Marked-Up Current Dresden Unit 2 and Quad Cities Unit 2 Technical Specifications

DRESDEN II DPR-19 Amendment No. 8/2, 8/4, 91

Marked-Up Draft Revision 4 of the BWR/4 Standard Technical Specifications

5.6 Seismic Design

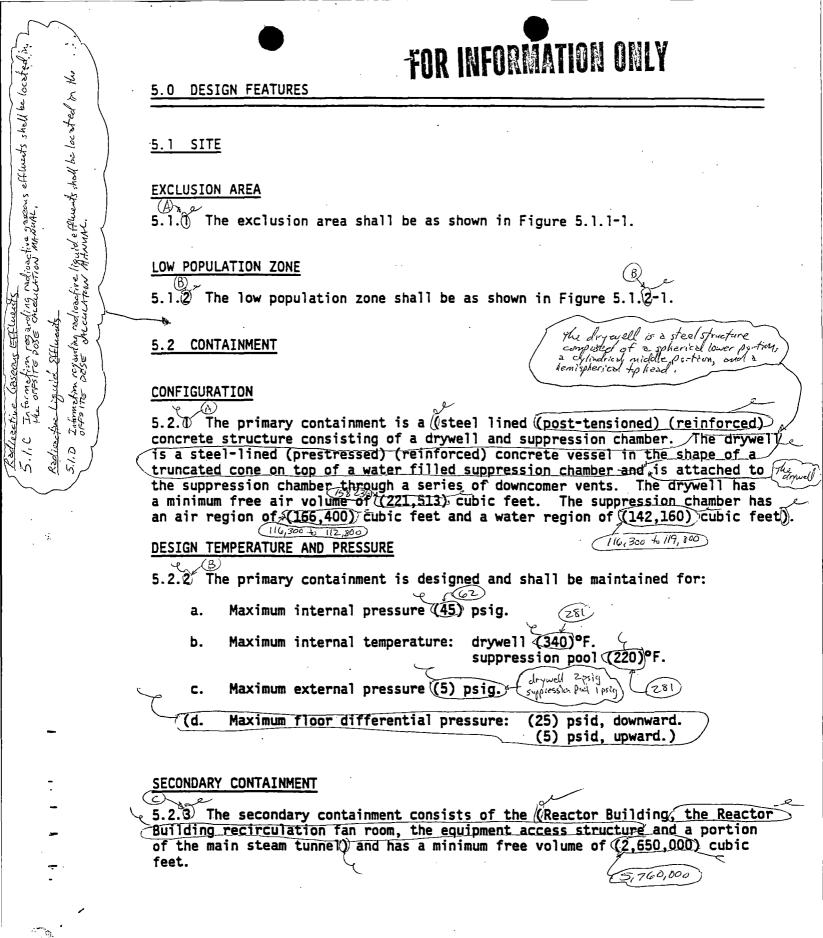
The reactor building and all contained engineered safeguards are designed for the maximum credible earthquake ground motion with an acceleration of 20 per cent of gravity. Dynamic analysis was used to determine the earthquake acceleration, applicable to the various elevations in the reactor building.
